Wanhao D7 Correction on 16th April 2017
D7 V1.3 to be released on 13th April 2017

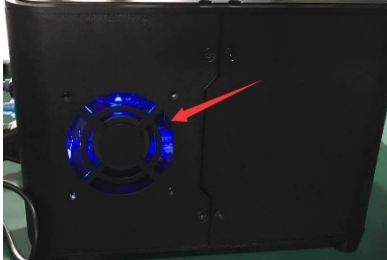
D7 Version 1.3 issue		D7 Version 1.4 improvement	
Pic	issue	Pic	Improvement
	<p>1</p> <p>There is one intake 40*40mm fan beside the UV light. The printer is warm during printing.</p>		<p>1</p> <p>We add the 60*60mm fan above the motherboard and on side of printer. The printer is much cooler than before.</p>
	<p>2</p> <p>The power button at front. We have lot issue of LED light.</p>		<p>2</p> <p>We use better switch without LED light.</p>
